Beacon Fen Energy Park – Development Consent Order

Application reference: EN010151

Document: Deadline 4 – Matrix Comparator Clarification (LCJMF Hybrid) and Targeted Rule 17 Request (CAH1 follow-up)

Diagram 3

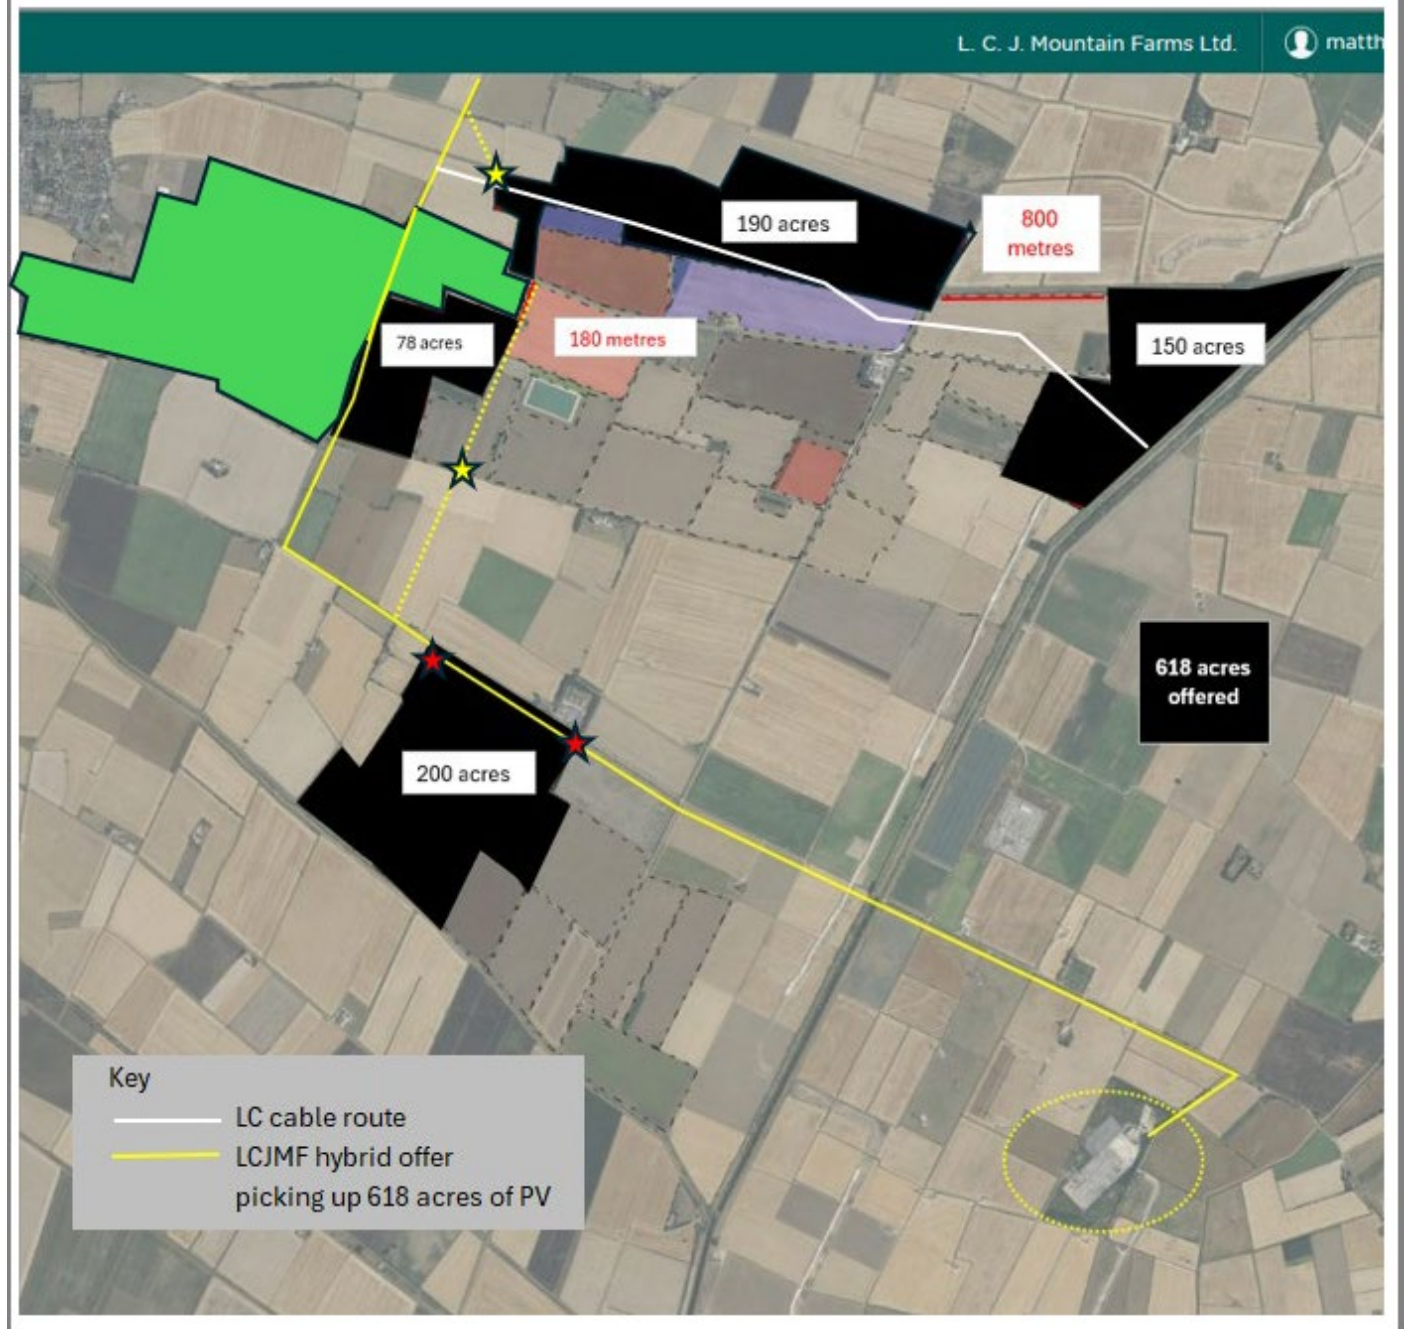
LCJMF is only a tenant of the area edged blue/filled bright green (Diagram 2) and cannot grant north–south passage through that area [solid yellow line].

LCJMF can grant passage along the ExD2.11 yellow dotted line between the yellow stars in Great Hale Fen (1,500 m) and the red stars in Little Hale Fen (750 m)—2,250 m total (Diagram 3).

Diagram 4

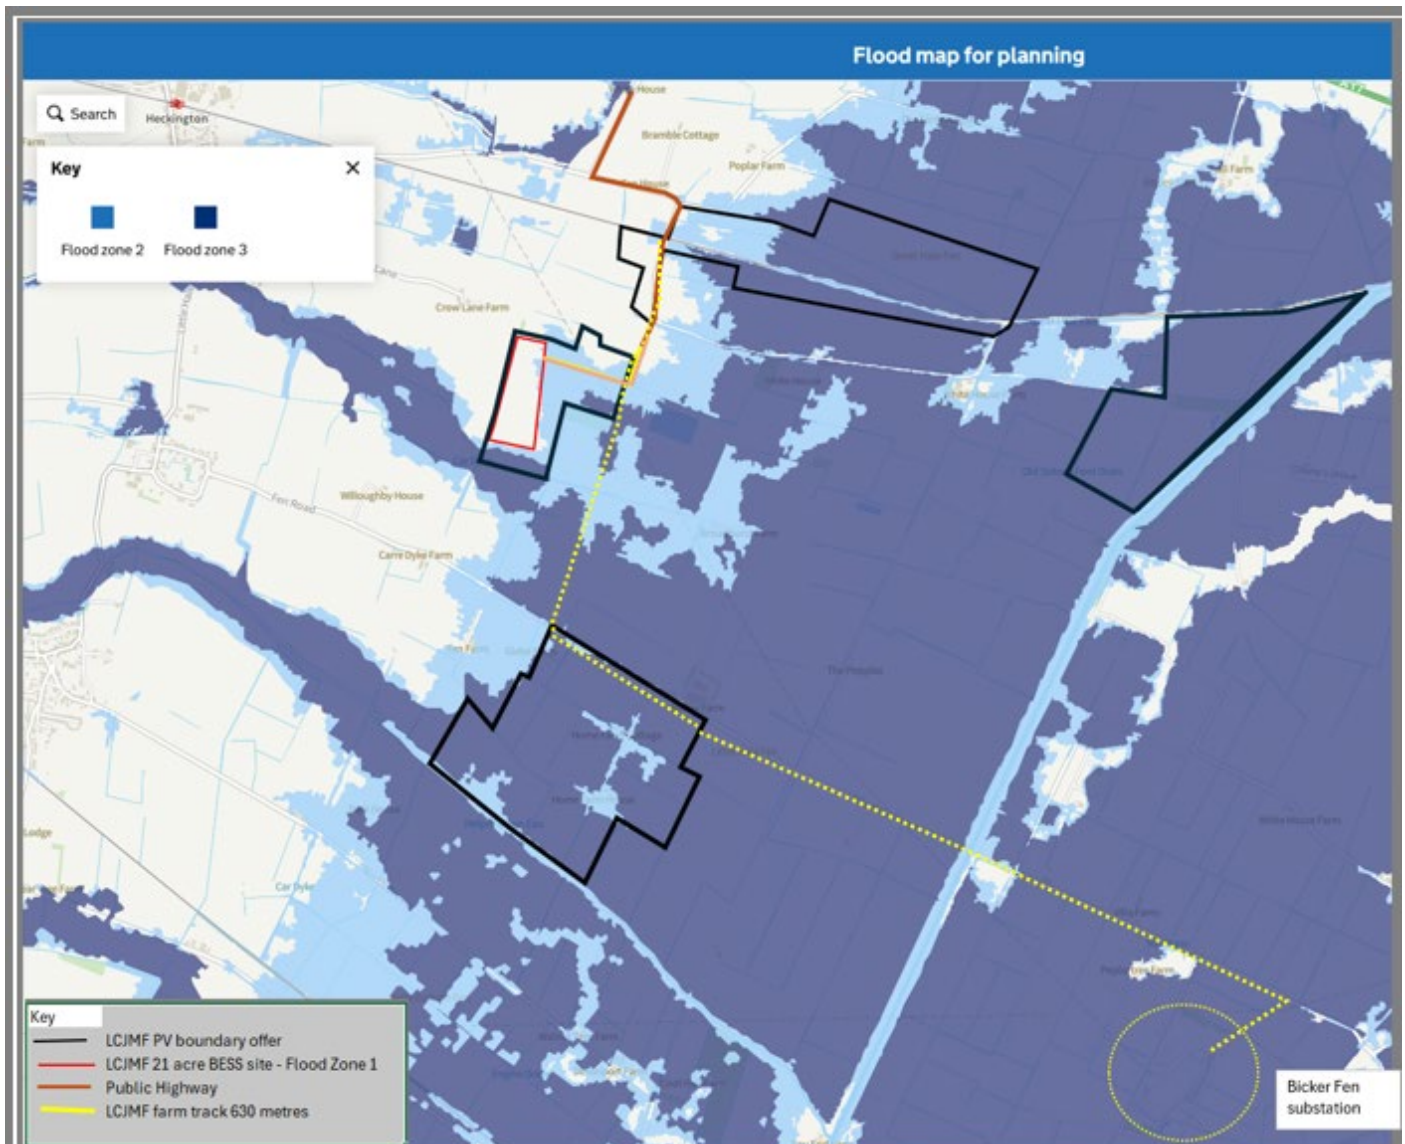
- **Grid headroom & land-use logic:** The ExD2.11 yellow dotted line captures the 618 acres in LCJMF's Aug-2023 solar offer (198 MW at 0.32 MW/ac), aligning with the Applicant's stated 200MW BESS headroom for "other uses" [additional / sequential generation] discussed under ISH2, Agenda 3 with the BESS sited on 21 acres in Flood Zone 1 [red block below – Diagram 4].

- **Construction feasibility:** Robust farm access (brown routes on Diagram 4); 3–5 km from PoC; Grade 3 land per LCJMF 30-year cropping records and the AGR3 ALC outcome (Rep1-043).
